END OF ADDENDUM NO. 3

CBSA
 Uniform Small Port of Er

Electrical Underground

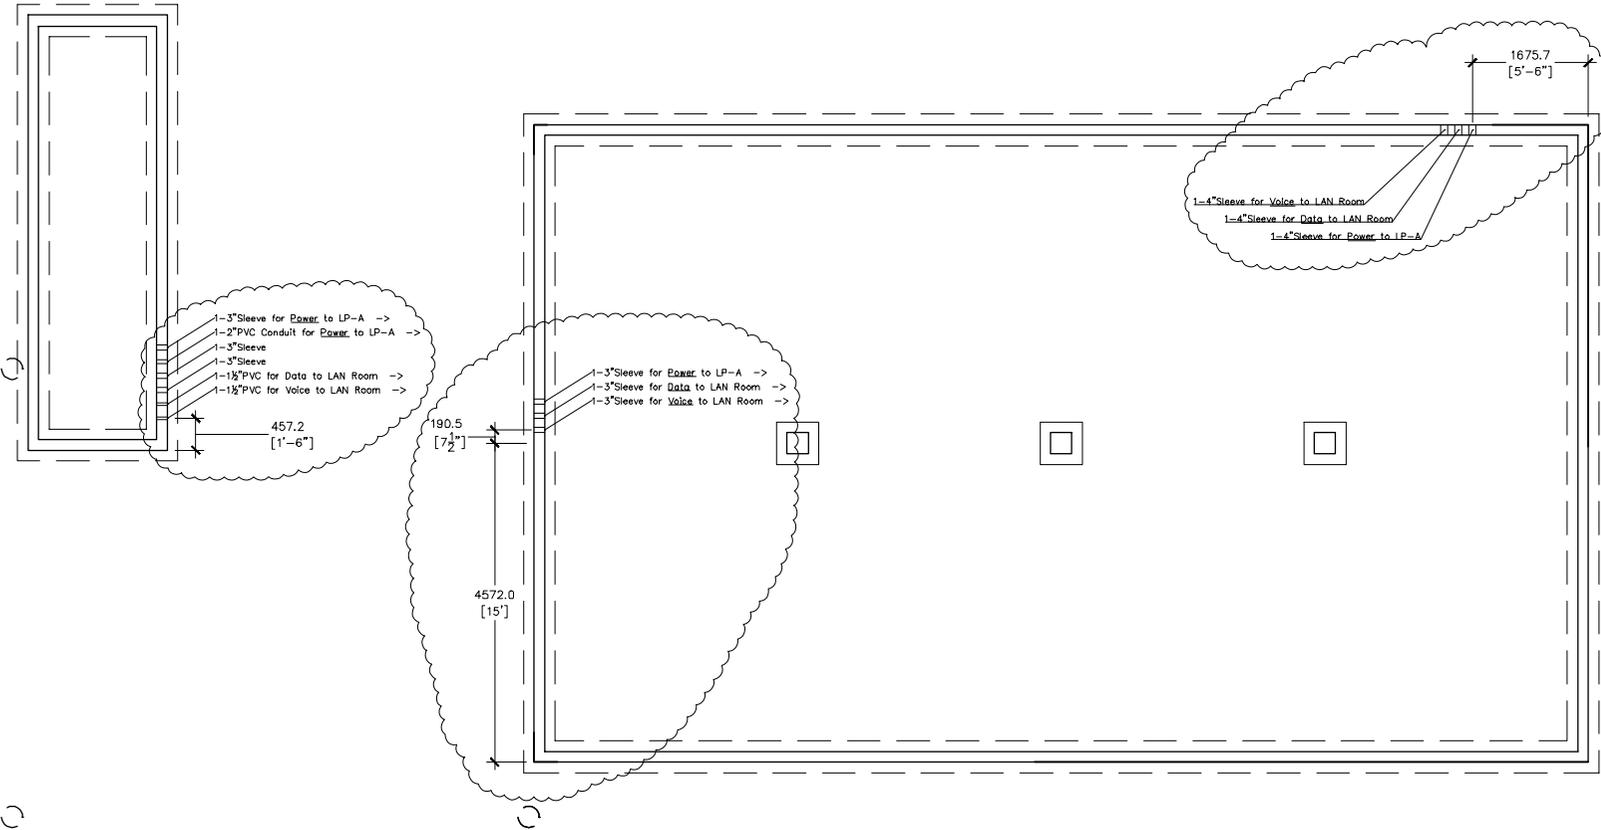
Q4. In Addendum No. 2, there is reference to review the Corcan drawings for the location of all sleeve penetrations in the foundation wall, but these drawings have not been provided. Will they be provided?

****INITIAL PENETRATIONS MAY CHANGE LOCATION IF
 POWER COMES IN FROM ANOTHER DIRECTION****

A4. See the attached Corcan drawing. This is a typical representation, the exact locations for each site will be determined on the issue for construction drawings.
